Product change information (PCN)

PCN No.:	A01-11148	Date:	12.07.2019
Products:	Optimization of the HESI lever

Optimization of the HESI lever

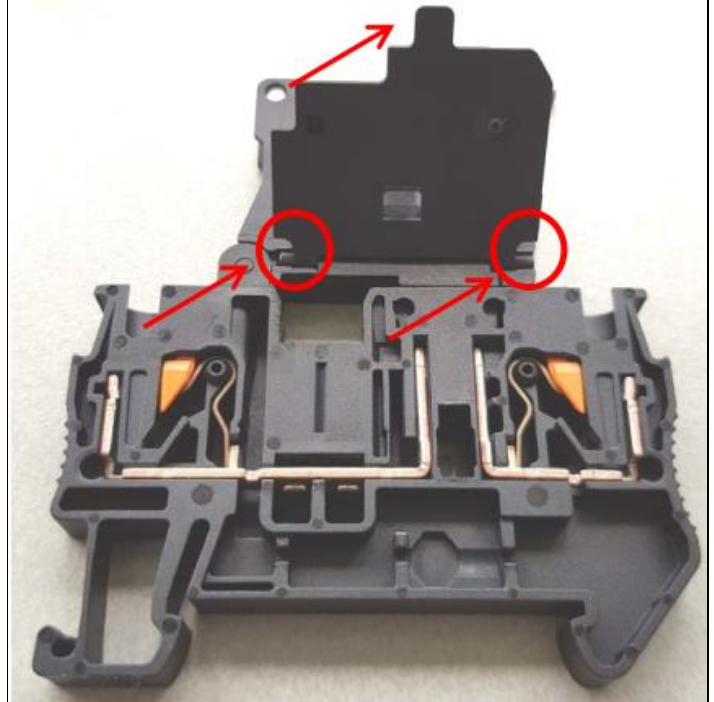
<p>These changes (marked by arrows) only affect the lever. The labeling field was made smaller. Additional cutouts were added. The grip was optimized so that the lever can be opened more easily.</p>

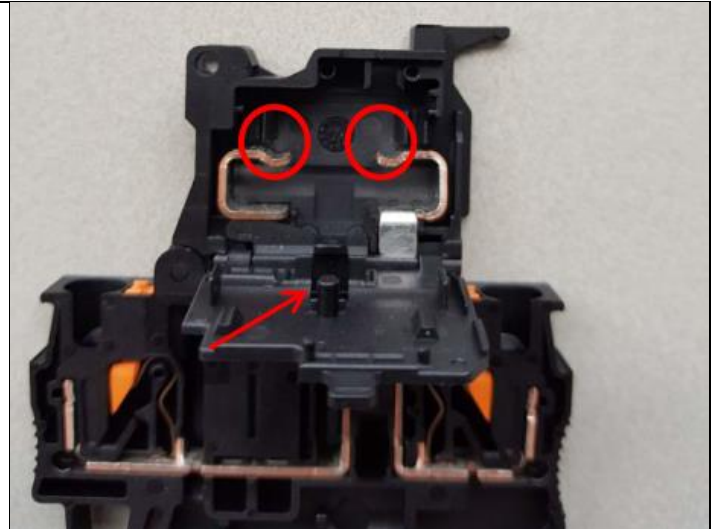
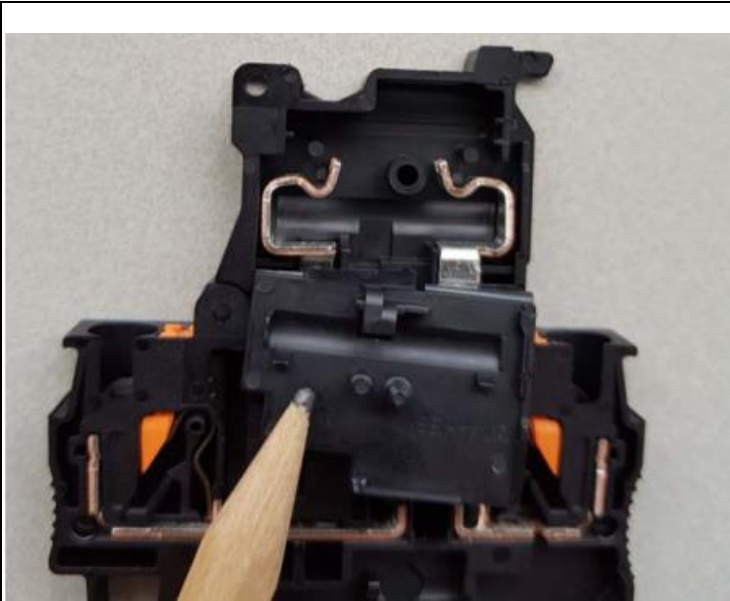
The grip was improved so that the lever can be opened more easily. A grip was also added so that the cover of the fuse chamber is easier to open. Furthermore, the window for the LED was made smaller.

The previous folding mechanism for opening the fuse chamber was replaced by hinges (circles). Above, the new grip can be seen.

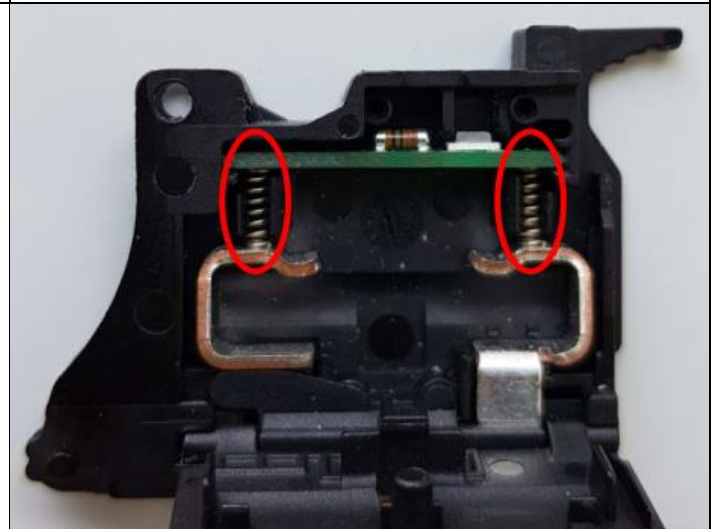
The design of the metal latch was adapted, and the tab to hold the fuse changed.

The addition of springs means that the HESI LED levers provide better contact quality.
